Agenda
Village of Arlington Heights
Design Commission
Community Room, 3rd Floor

Arlington Heights Village Hall
33 S. Arlington Heights Road
Arlington Heights, IL 60005
August 26, 2014
6:30 PM

DATE: August 26, 2014
TO: Chairman Eckhardt and Members of the Design Commission
FROM: Steve Hautzinger, Design Planner
RE: **DC Number: 14-058, Hickory/Kensington Area Design Guidelines**

ELEVATION STUDY MODEL

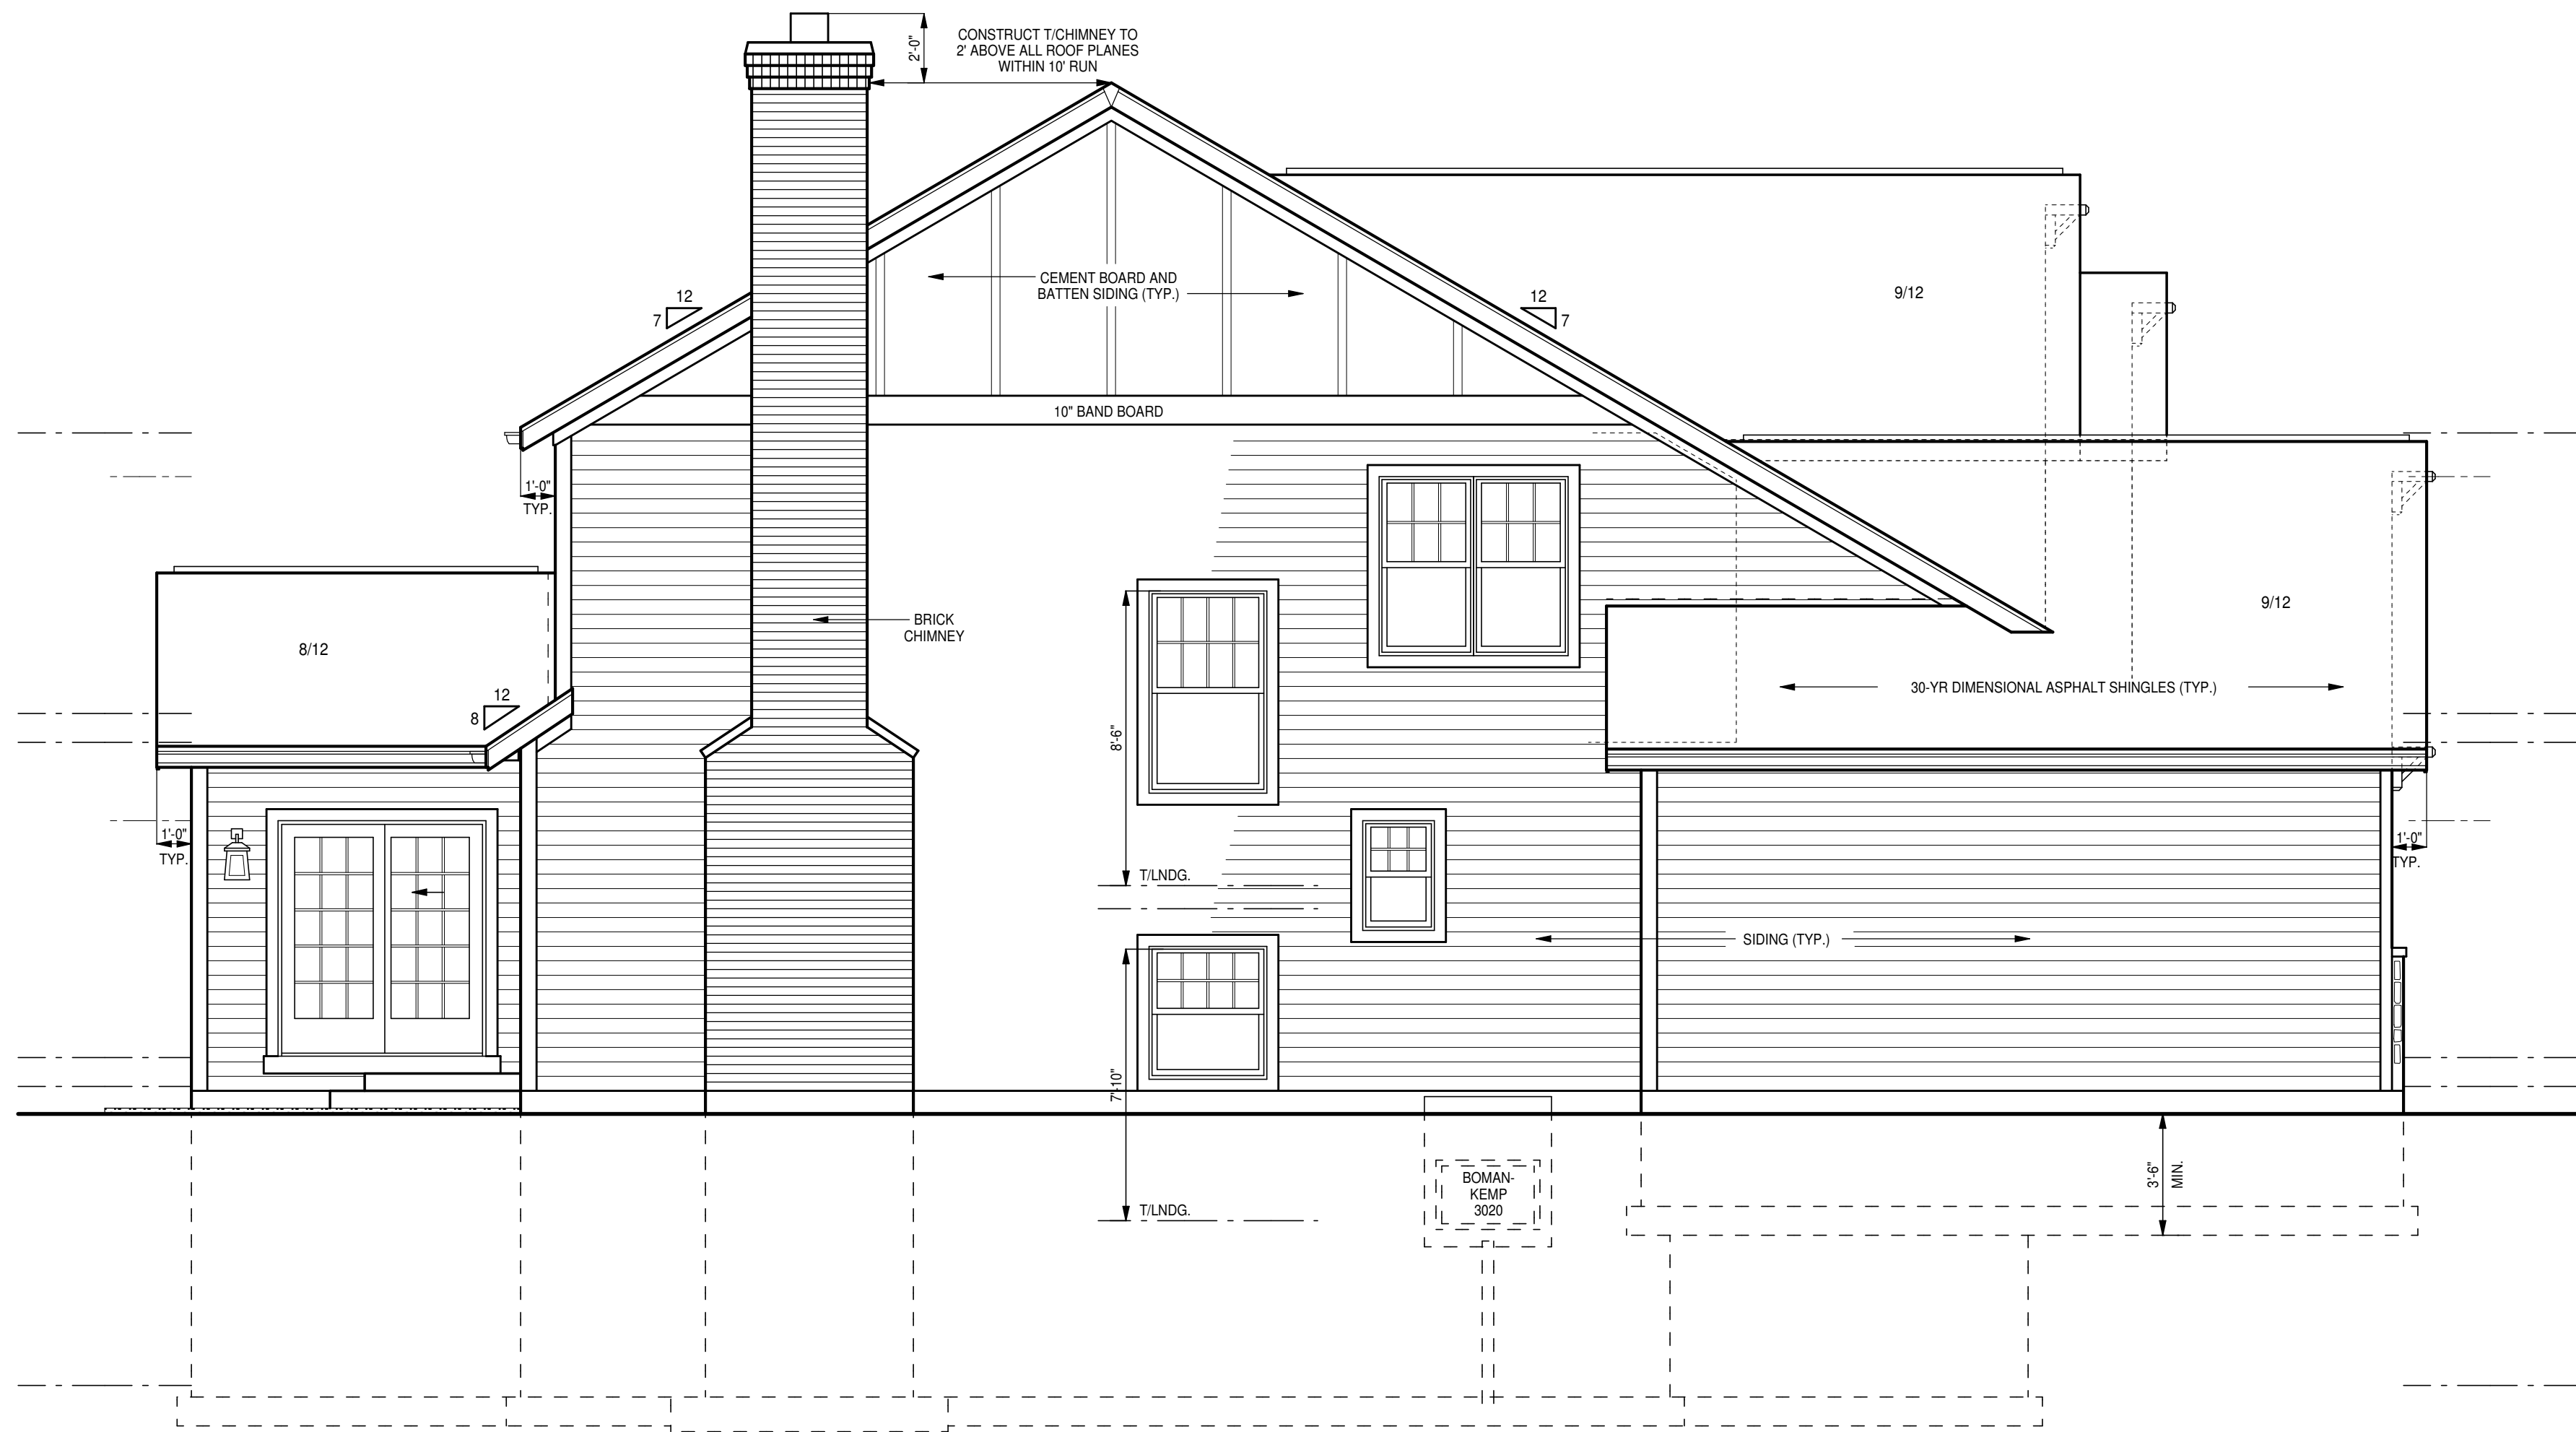
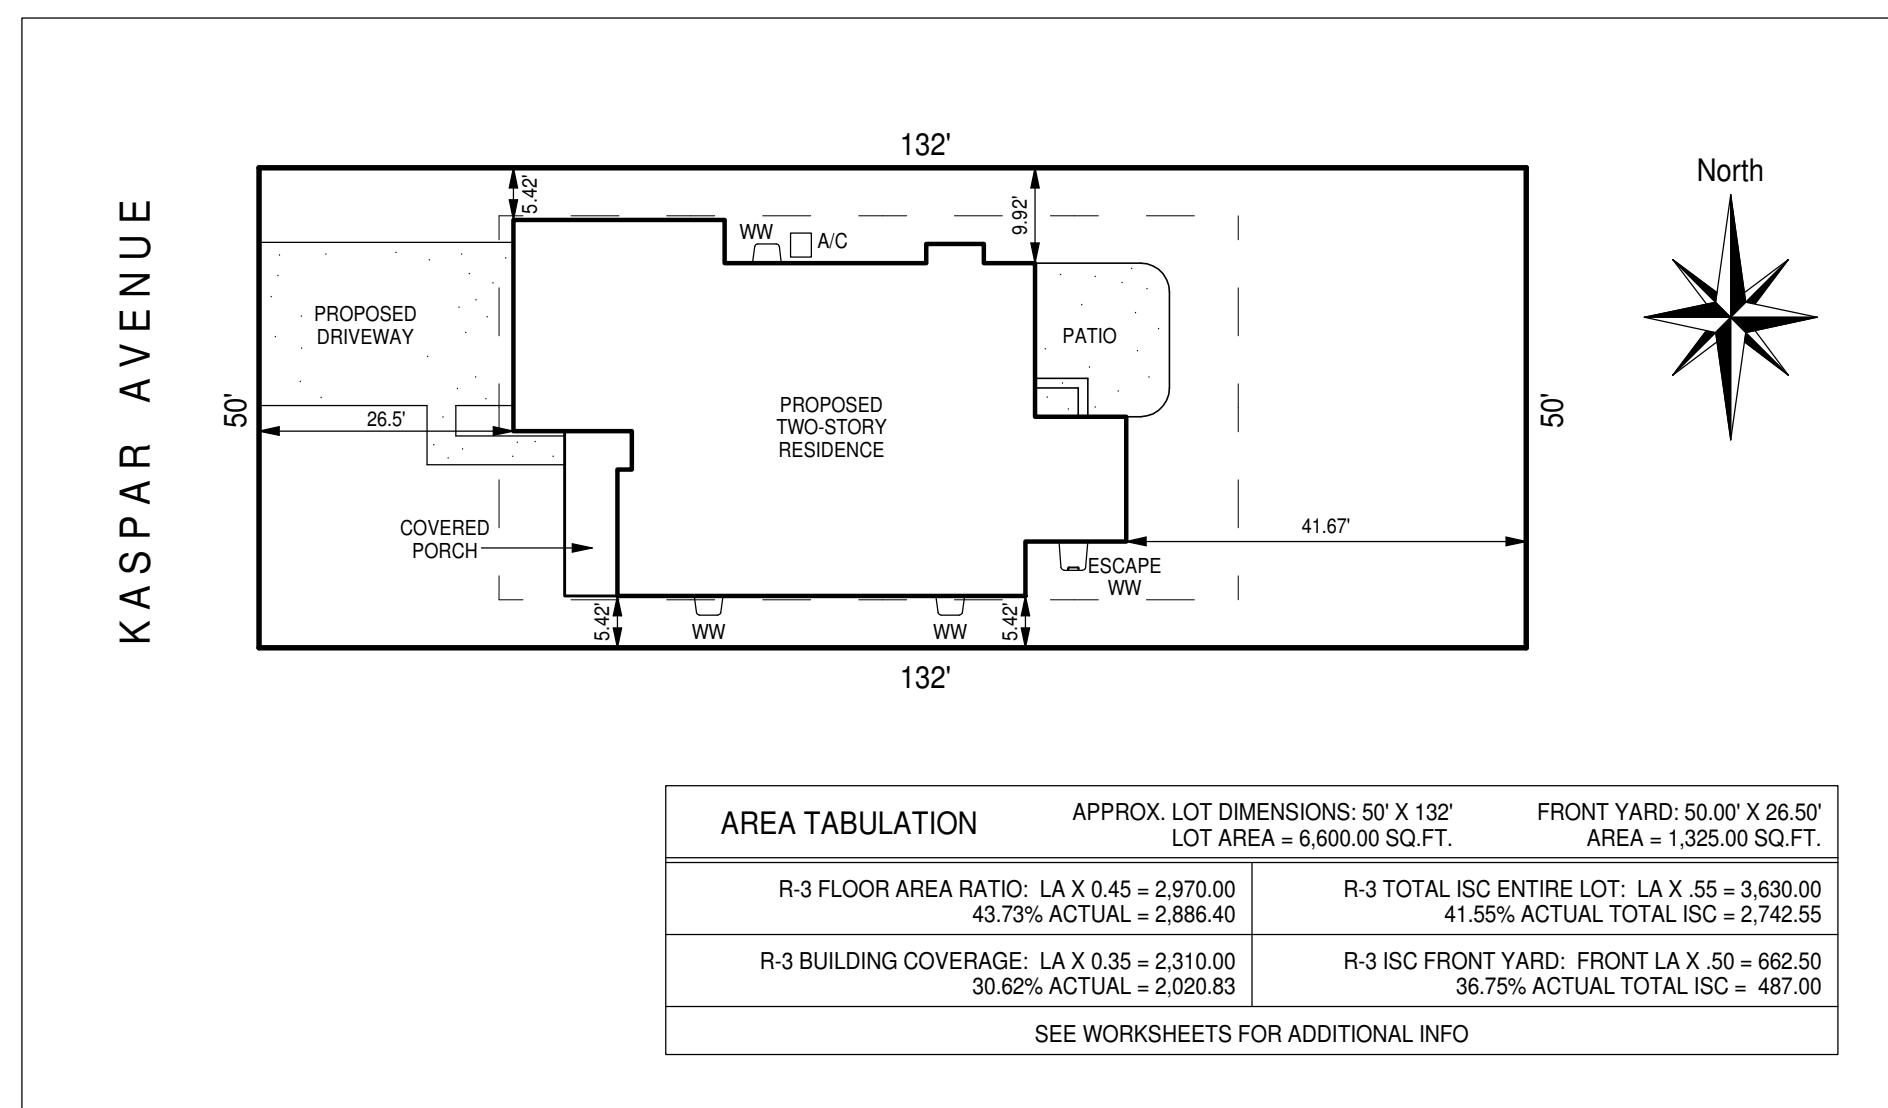
It is recommended that the Design Commission evaluate the proposed new single-family residence to be located at 815 N. Kaspar Avenue. This recommendation is subject to compliance with the architectural plans received 7/30/14, and the following:
